***Interactive comment on “Technical note:
Single-shell $\delta^{11}\text{B}$ analysis of *Cibicidoides
wuellerstorfi* using femtosecond laser ablation
MC-ICPMS and secondary ion mass
spectrometry” by Markus Raitzsch et al.***

Dennis Mayk (Referee)

Fig. 1.

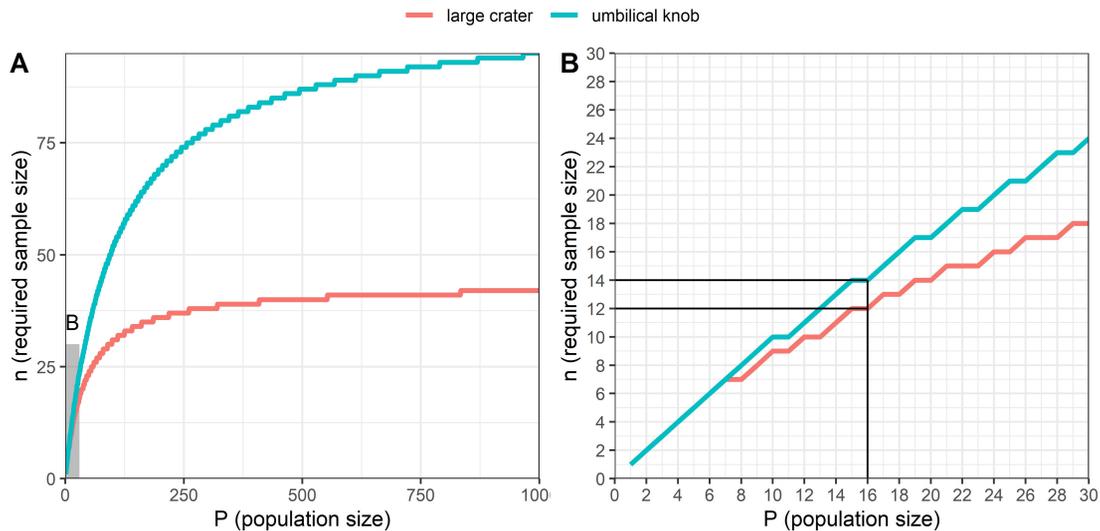
Considering the sample size of 16 or 18 it appears to be useful to consider the use of a conventional sample size estimation approach in comparison to a resampling approach as drawing from the same small population may result in errors. In the figure below, the estimated sample sizes required for $e = 0.5$ (2SD) and $1 - \alpha = 0.05$ in relation to the population size is given as estimated by the R function “sample.size.mean()” (<https://CRAN.R-project.org/package=samplingbook>) for both measurement “types”. Given an overall population size of e.g., 500 specimens in the same pH-environment, it would require $n = 87$ specimens if the “umbilical knob” was measured and $n = 40$ if the “large crater” was measured (based on the variability observed in this study) to achieve the desired significance level. Even if the population size consisted of only 16 individuals, the estimated sample size would be $n = 16$ and $n = 14$, respectively and thus twice as large as reported in the manuscript.
